CITY OF OPELIKA
HISTORIC PRESERVATION COMMISSION
May 14, 2026
4:30 p.m.
Meeting Chambers at Opelika Municipal Courtroom
300 MLK Boulevard

HISTORIC PRESERVATION COMMISSION MINUTES

City of Opelika
Historic Preservation Commission
Staff Report

Right side facing 5th Ave

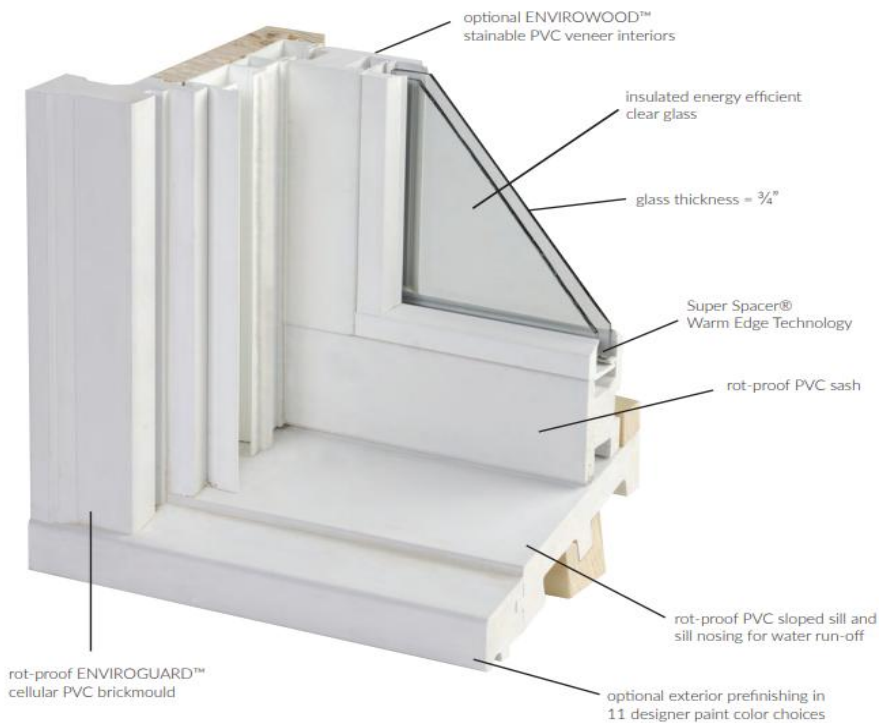
1. Replace thirteen (13) windows on side and rear with Enviroguard double hung paint grade cellular PVC composite windows with SDL interior/exterior grids. Some windows are 1/1 and others are 6/6. Front windows will remain.

1. Staff recommends approval of replacement Enviroguard PVC composite windows on side and rear with matching SDL exterior grids currently in place. All exterior molding should be the same width as current moldings.

Proposed Guidelines:

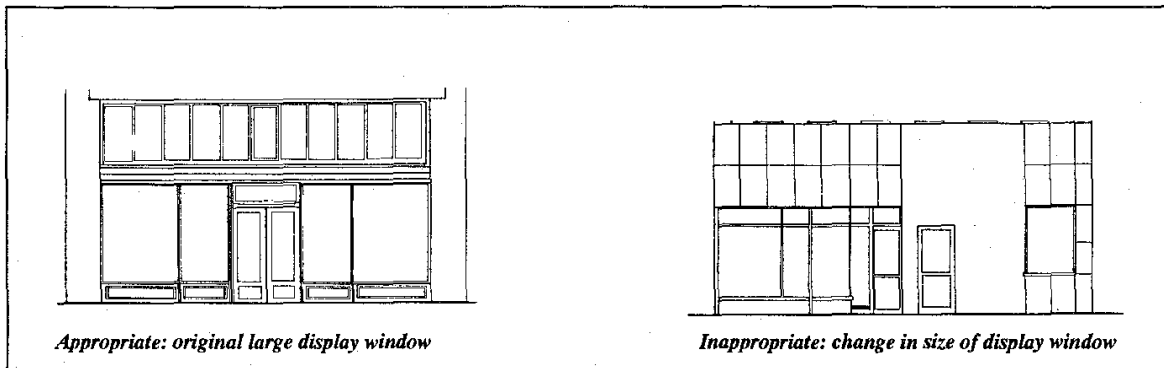
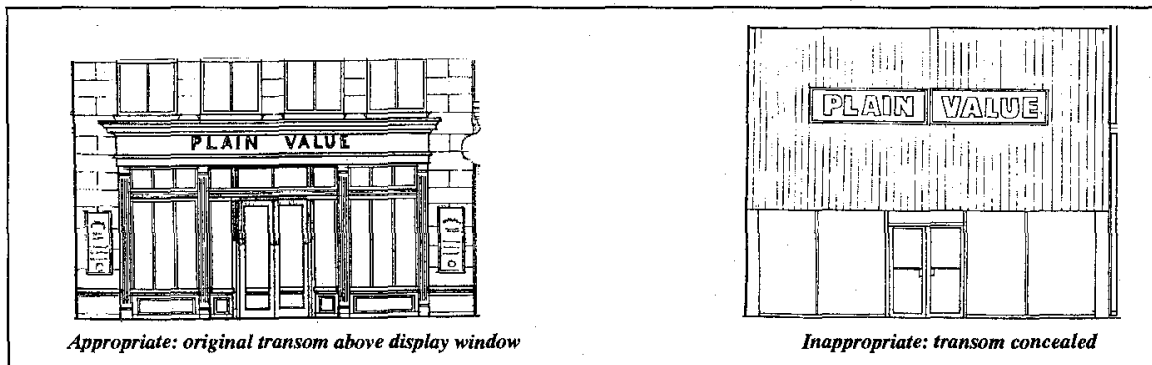
1. Remove all existing plywood siding to expose existing brick, touch up, and paint.
2. Remove existing 3'0" x 8'0" residential door and install new wood door.
3. Install new fiber cement sheathing, wrap framing to box-in storefront windows, and frame transoms above with Hardie panels and trim.
4. Add two light fixtures at residential entry door.

1. Staff recommends removing all existing T-111 siding to expose existing brick and iron columns, touch up brick pointing, and painting to match existing facade.
2. Staff recommends replacing residential door with a new wood door of like kind. Specs for the new door shall be submitted for Staff approval prior to installation.
3. Staff recommends installing new fiber cement sheathing, wrap framing to box-in storefront windows, and frame transoms above with Hardie panels and trim.
4. Staff recommends adding two light fixtures at residential entry door. Specs for lighting shall be submitted for Staff approval prior to installation.
